Access Audit Site Report

Lake Casa Blanca International State Park

Accessibility Evaluation

Inspection Date: 10/04/2021

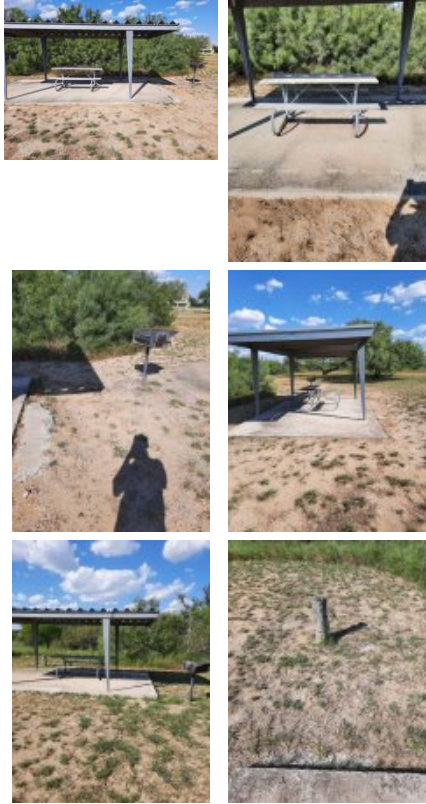
Finding Number	Area Description	Lat/Long	Finding	As Built	Recommendation	Citation	Photos	Figure
61	Activity Area: Activity Area Baseball Field Parking	[27.5410381 , -99.449316 8]	The accessible parking stall signage is incorrect and/or missing from each accessible parking space. Parking space identification signs shall include the International Symbol of Accessibility. Signs identifying van parking spaces shall contain the designation "van accessible." Signs shall be 60 inches minimum above the finish floor or ground surface measured to the bottom of the sign.	one stall lacks sign, only one sign at back to back angled stalls	Acquire and mount at appropriate heights and locations accessible parking signs where missing	2015 ABAAS Section: 502.6 2012 TAS Section: 502.6		
62	Activity Area: Activity Area Baseball Field Parking	[27.5410429 , -99.44909 95], [27.5410647 , -99.449303 4]	The van stall is missing a sign identifying it as a van accessible stall. Parking space identification signs shall include the International Symbol of Accessibility. Signs identifying van parking spaces shall contain the designation "van accessible."	Lacks van accessible sign	Add one van parking sign to van accessible stall and ensure stall and access aisle are 11' and 5' or 8' and 8'	2015 ABAAS Section: 502.6 2012 TAS Section: 502.6 2010 ADAS Section: 502.6

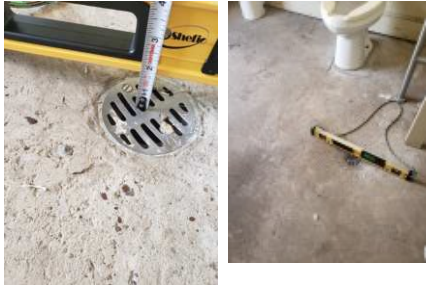
Finding Number	Area Description	Lat/Long	Finding	As Built	Recommendation	Citation	Photos	Figure
89	Ranchito Group Facility: Ranchito Group Facility Parking	[27.5455881 , -99.4410856]	The accessible parking stall signage is incorrect and/or missing from each accessible parking space. Parking space identification signs shall include the International Symbol of Accessibility. Signs identifying van parking spaces shall contain the designation "van accessible." Signs shall be 60 inches minimum above the finish floor or ground surface measured to the bottom of the sign.	one stall lacks sign	Acquire and mount at appropriate heights and locations accessible parking signs where missing	2015 ABAAS Section: 502.6 2012 TAS Section: 502.6		
90	Ranchito Group Facility: Ranchito Group Facility Parking	[27.5456924 , -99.440757]	The van stall is missing a sign identifying it as a van accessible stall. Parking space identification signs shall include the International Symbol of Accessibility. Signs identifying van parking spaces shall contain the designation "van accessible."	The van stall is missing a sign identifying it as a van accessible stall	Add one van parking sign to one accessible stall and repaint stall and access aisle to 11' and 5' or 8' and 8'	2015 ABAAS Section: 502.6 2012 TAS Section: 502.6 2010 ADAS Section: 502.6

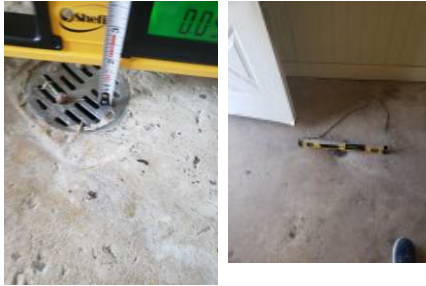
99	Ranchito Group Facility: Ranchito Group Facility Mens Restroom	[27.5453326 , -99.440680 1]	The flush handle is located on the wrong side of the toilet. Controls shall be operable with one hand and shall not require tight grasping, pinching or twisting. Controls for the flush valves shall be mounted on the wide side of toilet areas, no more than 44 inches above the floor.	The flush handle is located on the wrong side of the toilet	Replace toilet tank with one having flush mechanism on the open side, in the alternative, install an auto flush unit	2015 ABAAS Section: 604.6 2012 TAS Section: 604.6 2010 ADAS Section: 604.6		
100	Ranchito Group Facility: Ranchito Group Facility Mens Restroom	[27.5453213 , -99.440690 8]	The toilet paper is not installed within the compliant range in front of the toilet. Toilet paper dispensers shall be 7 inches minimum and 9 inches maximum in front of the water closet measured to the centerline of the dispenser. The outlet of the dispenser shall be 15 inches minimum and 48 inches maximum above the finish floor and shall not be located behind grab bars. Dispensers shall not be of a type that controls delivery or that does not allow continuous paper flow. There shall be a clearance of 1 1/2 inches minimum below the grab bar.	toilet paper location fails	Remount toilet paper dispenser max 7" to 9" from front of toilet, 15" to 48" aff and min 12" above or 1.5" below grab bar	2015 ABAAS Section: 604.7 2012 TAS Section: 604.7 2010 ADAS Section: 604.7

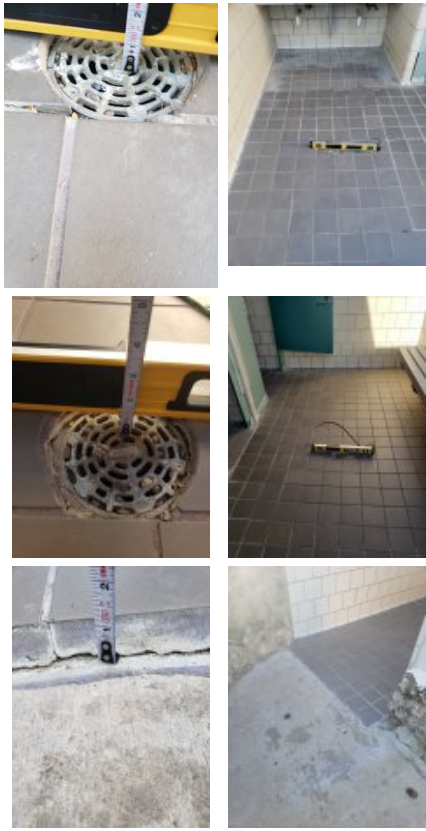
241	Day Use Area G: Day Use Area G Mens Restroom	[27.5393595 , -99.448104 4]	The side grab bar is not long enough. The side grab bar must extend at least 54 inches minimum beyond the rear wall and start a maximum of 12 inches from the rear wall. A 42 inch grab bar installed the maximum distance from the rear wall (12 inches) will leave the leading end 54 inches from the rear wall. Grab bars shall be installed in a horizontal position, 33 inches minimum and 36 inches maximum above the finish floor measured to the top of the gripping surface.	Side grab bar 36" long and extends 38" from rear wall	Replace side grab bar with a 42" long grab bar, mounted max 12" from the rear wall at the close end and min 54" on the far end and 33" to 36" aff	2015 ABAAS Section: 604.5.1 2012 TAS Section: 604.5.1 2010 ADAS Section: 604.5.1

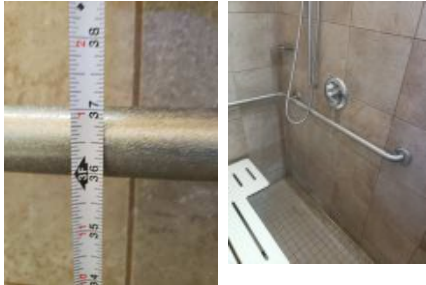
Finding Number	Area Description	Lat/Long	Finding	As Built	Recommendation	Citation	Photos	Figure
353	Area J: Area J Mens Restroom	[27.5353009 , -99.436344 3]	The restroom sign does not comply with one or more applicable requirements for the location, height, and properties of the sign.	sign faded	Replace sign with one of contrasting colors that includes Braille, raised characters, and the symbol of accessibility and mount on the wall, latch side of the door, 48" to the baseline of the lowest character and 60" to the baseline of the highest character	2015 ABAAS Section: F216.2, 703.1, 703.2, 703.5, 703.6 2012 TAS Section: 216.2, 703.1, 703.2, 703.5, 703.6 2010 ADAS Section: 216.2, 703.1, 703.2, 703.5, 703.6		
354	Area J: Area J Mens Restroom	[27.5352481 , -99.436324 1]	The grab bar height and/or spacing fails. Grab bars must be mounted between 33" and 36" to the top of the gripping surface. There must be 1.5" of clearance between the grab bar and the wall. There must be a minimum of 1.5" of clearance below and minimum 12" above the grab bar to any dispenser or other obstruction.	Gripping surface of grab bar is 37" aff	Remount grab bars in accessible stall to 33" to 36" aff	2015 ABAAS Section: 609.3, 609.4 2012 TAS Section: 609.4, 609.3 2010 ADAS Section: 609.3, 609.4

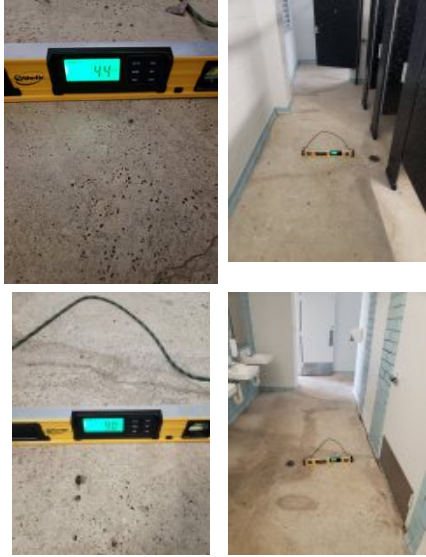
397	Area K: Area K Mens Restroom	[27.5366323 , -99.432748 8]	Shower controls are in the incorrect location In transfer type shower compartments, the controls, faucets, and shower spray unit shall be installed on the side wall opposite the seat 38 inches (965 mm) minimum and 48 inches (1220 mm) maximum above the shower floor and shall be located on the control wall 15 inches (380 mm) maximum from the centerline of the seat toward the shower opening.	Shower controls 52" aff	Remount shower controls to the correct location in the transfer shower	2015 ABAAS Section: 608.5.1 2012 TAS Section: 608.5.1 2010 ADAS Section: 608.5.1

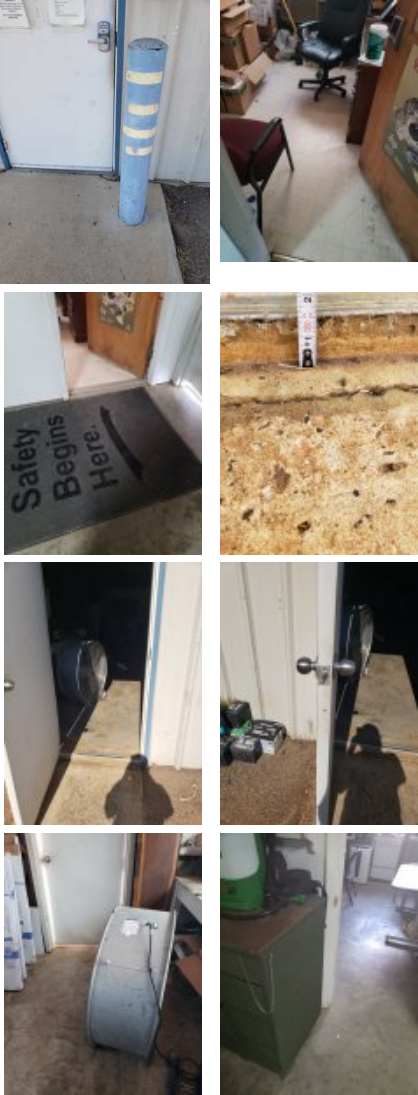
467	State Park Police: Gym Mens Restroom	[27.5416332 , -99.451757 6]	The restroom is not compliant. The restroom does not have the required minimum clear floor space or maneuvering clearances for the toilet. The restroom does not have the required minimum clear floor space or maneuvering clearances for the lavatory. The entry door does not contain the required minimum maneuvering spaces on the pull/push sides. The entry door encroach into the required clear floor space for fixtures. Grab bars are missing and/or incorrectly installed. Accessories, such as toilet seat covers, paper towel holders, garbage cans, hand dryers, and mirrors are either too high or without clear floor space or both.	Lacks toilet stall with required dimensions to be wheelchair accessible	Create a compliant wheelchair accessible restroom and correct all features to be accessible if feasible.	2015 ABAAS Section: 603.1 2012 TAS Section: 603.1 2010 ADAS Section: 603.1

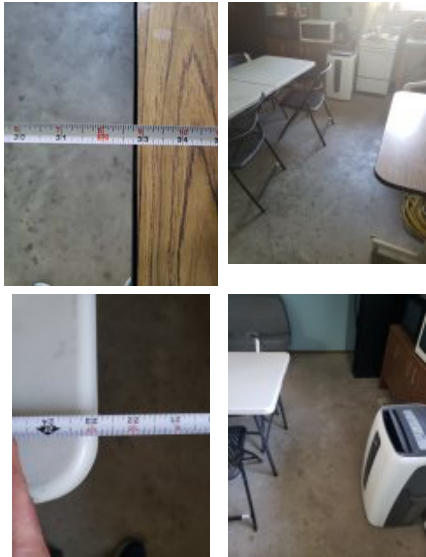
469	State Park Police: Gym Mens Restroom	[27.5416315, -99.451779]	The bench is not deep enough or long enough or is missing. Benches shall be provided having seats that are 42 inches long minimum and 20 inches deep minimum and 24 inches deep maximum. The bench shall provide for back support or shall be affixed to a wall. Back support shall be 42 inches (1065 mm) long minimum and shall extend from a point 2 inches (51 mm) maximum above the seat surface to a point 18 inches (455 mm) minimum above the seat surface. Back support shall be 2½ inches (64 mm) maximum from the rear edge of the seat measured horizontally. The top of the bench seat surface shall be 17 inches (430 mm) minimum and 19 inches (485 mm) maximum above the finish floor or ground.	bench 40" long, 11" deep	Replace bench in dressing area with one having a seat depth of 20" to 24" deep, 42" long, affixed to the wall or having a back and mounted 17" to 19" aff	2012 TAS Section: 903.4, 903.2, 903.3, 903.5 2010 ADAS Section: 903.4, 903.2, 903.3, 903.5
